Access Compliance Report

Public Rights-of-Way

(Curb Ramps)

Intersection ID: 10039530	Main Street: TEW_CT	Cross Street: N/A	Location: W
ADA ID: FA9741A35EDA	Ramp Type: Perp	Initial Pass/Fail: Fail	Overall Compliance: No
			Severity Score: 15

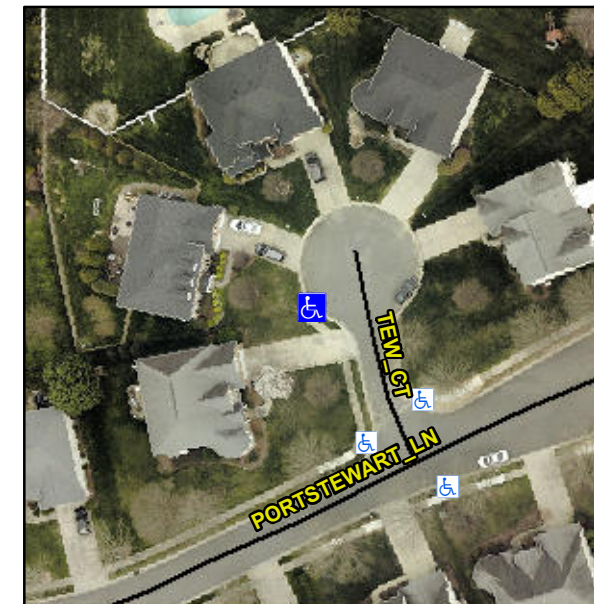
N/A	Ramp inside XWalk1?	N/A	N/A	Ramp inside XWalk2?	N/A
	Road Slope (%)	N/A	N/A	Clear Space?	N/A
	Road X Slope (%)	N/A	N/A	Clear Space to XWalk (in)	N/A
N/A	Any Obstructions?	N/A	N/A	Storm Grate/Utility Hazard?	N/A
	Obstruction Type			Storm Grate/Utility Type	
		N/A			N/A
		No		Surface Condition? (G/P)	Poor

Remove & Replace Entire Ramp.

R302.7
